- 8. Veal Subdivision 2026 Addition; KPB File 2026-009  
McLane Consulting Group / Veal  
Location: Miller Loop Rd, Autumn Rd & Robert Walker Ave  
Nikiski Area / Nikiski APC**

**ITEM #1- PRELIMINARY PLAT  
VEAL SUBDIVISION 2026 ADDITION**

<b>KPB File No.</b>	2026-009
<b>Plat Committee Meeting:</b>	February 23, 2026
<b>Applicant / Owner:</b>	Tim S. and Naomi L. Veal of Kenai, Alaska
<b>Surveyor:</b>	Andrew Hamilton, McLane Consulting, Inc.
<b>General Location:</b>	Autumn Road, Robert Walker Avenue, and Miller Loop Road, Nikiski

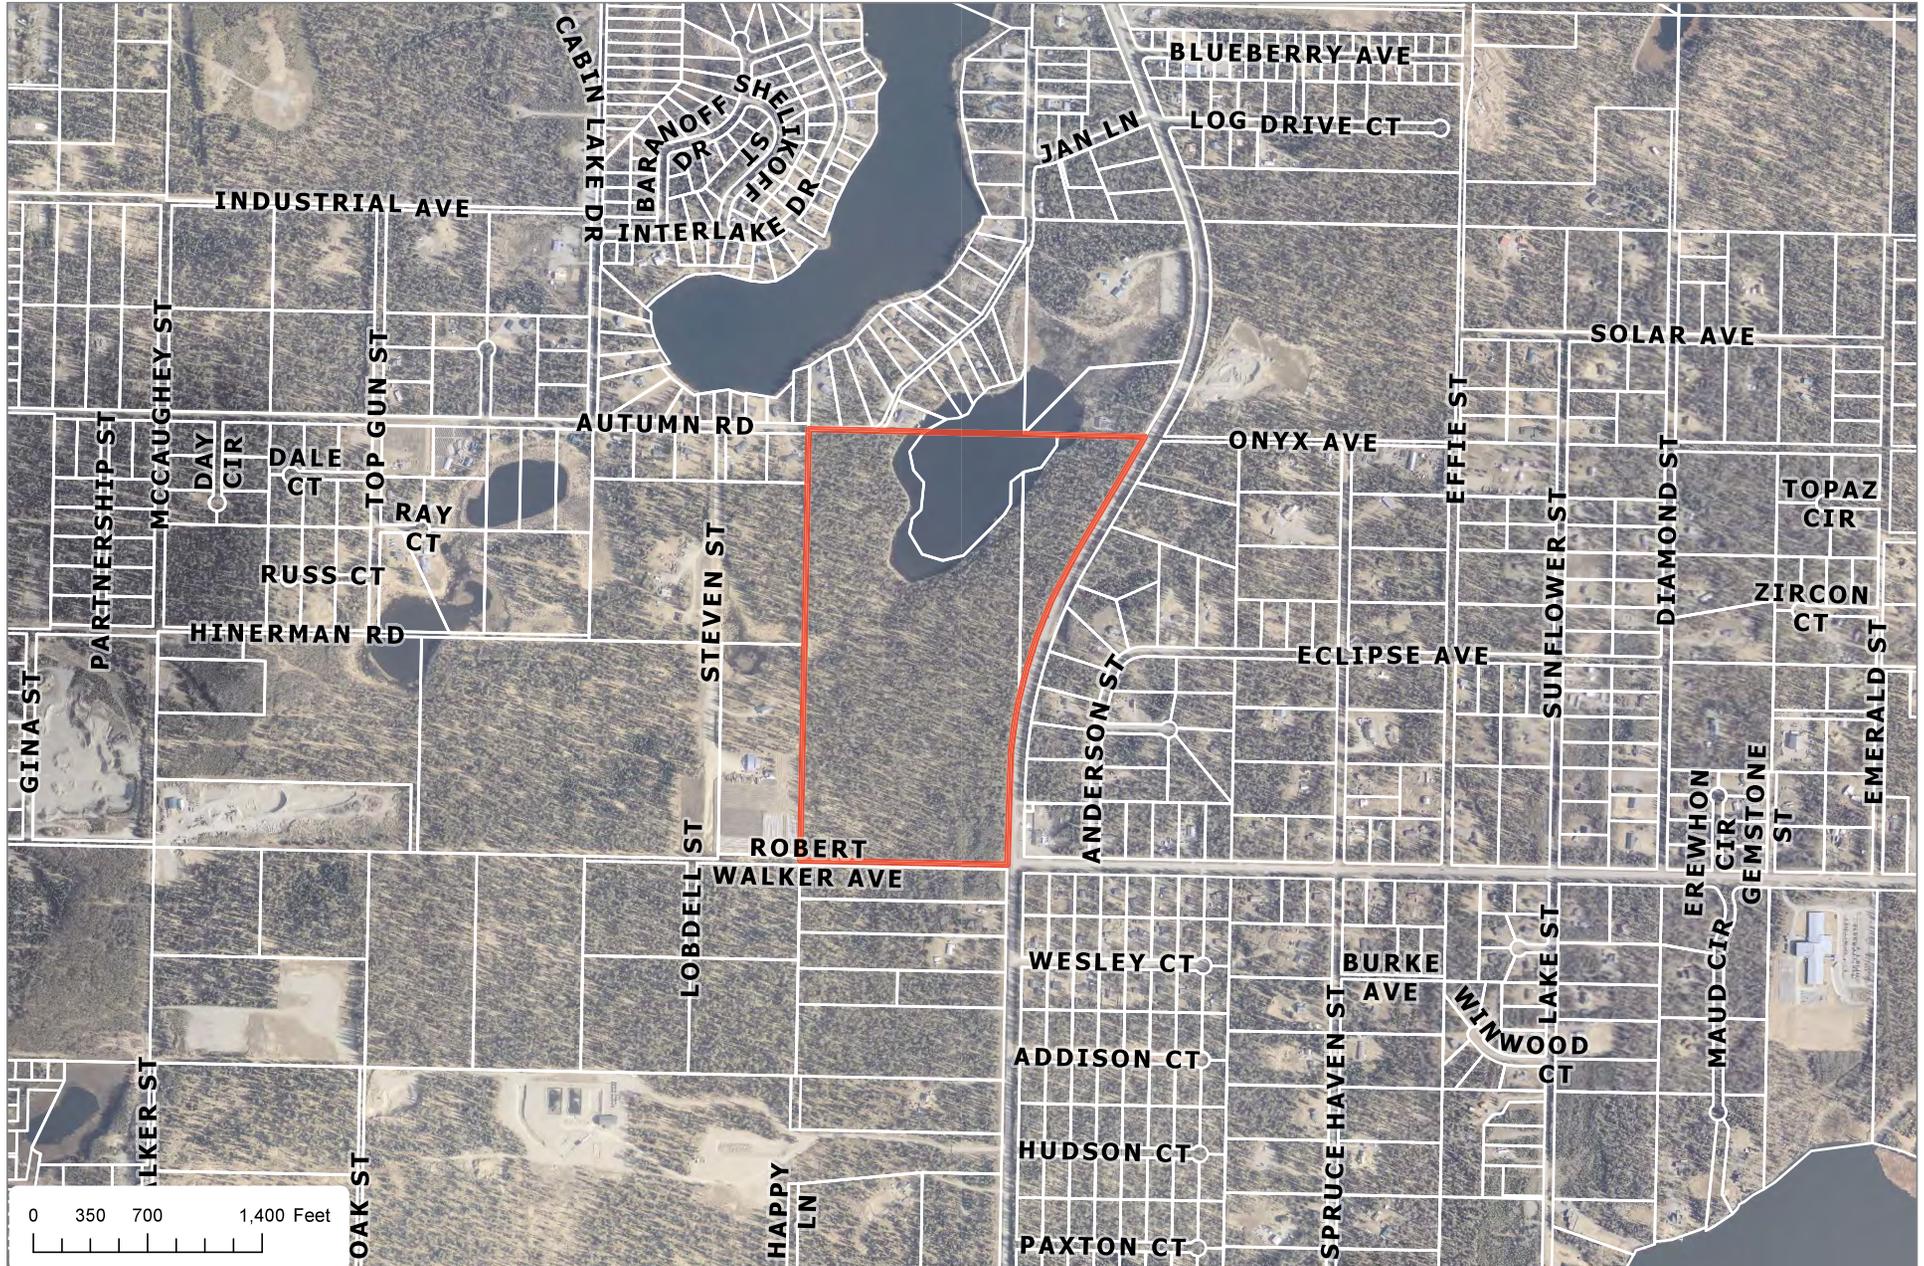
**Staff recommends** dedicate an additional 15 feet to the south side of Autumn Road to meet the full 60-foot right-of-way width requirement in KPB 20.30.120, and extending the right-of-way east to match the east limits of the northern dedication from the adjacent plat (plat KN 1429).

Per KPB 20.30.120 Street – Width Requirements A. the minimum right-of-way width of street shall be 60 feet. **Staff recommends** the applicant and the SOA DOT&PF to reach an agreement in right-of-way width and confirm the intention of Robert Walker Avenue. If the intent is to be a state maintained road, then the extra width would be justified, but being that the current intent is to be a borough maintained road, 60 feet is sufficient. Once reached, confirmation of the intent should be submitted to staff and if to be state maintained, prior to final approval, the plat shall need to return to the Plat Committee for reapproval of the plat and right-of-way.

A 66-foot section line easement, with 33 feet on either side of the section line, exists within Robert Walker Avenue. The northern portion of the section line easement is depicted and labeled on the plat. **Staff recommends** depict and label the southern portion of the section line easement and extend the easement to the west. Add a plat note to the plat referencing CTP item 11. **Staff recommends** the surveyor verify the section line easement may need to be shown running north along the joint section line of Sections 25 & 26 bisecting the plat and if so, show on the drawing.

The subdivision is located entirely within a non-regulatory Flood Zone, Zone D, an area of undetermined flood risk. **Staff recommends** adding the KPB 20.30.280 Flood Hazard Note, including reference to the Flood Zone and map panel 02122C-0040E. No depiction is required.

- o Modify plat note 5 to include KPB code reference 14.06.

- Staff recommendation:**
- o Modify the plat name in the title block: Veal Subdivision. Submittal form listed Veal Subdivision 2026 Addition which would be acceptable.

- Staff recommendation:**
- o Move section 26 outside of shaded area
  - o Provide labels for township and range
  - o Provide label for "this plat"
- F. The location, width and name of existing and platted streets and public ways, railroad rights-of-way, easements, and travel ways existing and proposed, within the subdivision;

- Staff recommendation:**
- o Extend Autumn Road dedication, curving to the northeast to match the northern dedicated portion (Plat KN 1429)
- G. The status of adjacent lands within 100 feet of the proposed subdivision boundary or the land status across from any dedicated rights-of-way that adjoin the propose subdivision boundary, including names of subdivisions, lot lines, block numbers, lot numbers, rights-of-way; or an indication that the adjacent land is not subdivided;

- Staff recommendation:**
- o 66' SLE on south boundary
  - o No SLE on east (?)
  - o Include right-of-way of roads formerly dedicated:
    - 15' Autumn Road northern portion

- 30' Autumn Road to the east
    - 60' Autumn Road to the west
    - 30' Robert Walker Avenue dedicated on the south
    - 60' Robert Walker Avenue to the west

- I. Approximate locations of areas subject to tidal inundation and the mean high-water line;
- Staff recommendation:**  
Add the mean high-water line.

- Lots 6 and 5 and Lots 4 and 3 shall have shared driveways.
- No direct access for Tract A onto Miller Loop Road.
- Lot 7 access is by Rosea Court.

**Staff recommendation:** Modify the certificate of ownership and dedication to reflect the proper owners as listed within the title block.
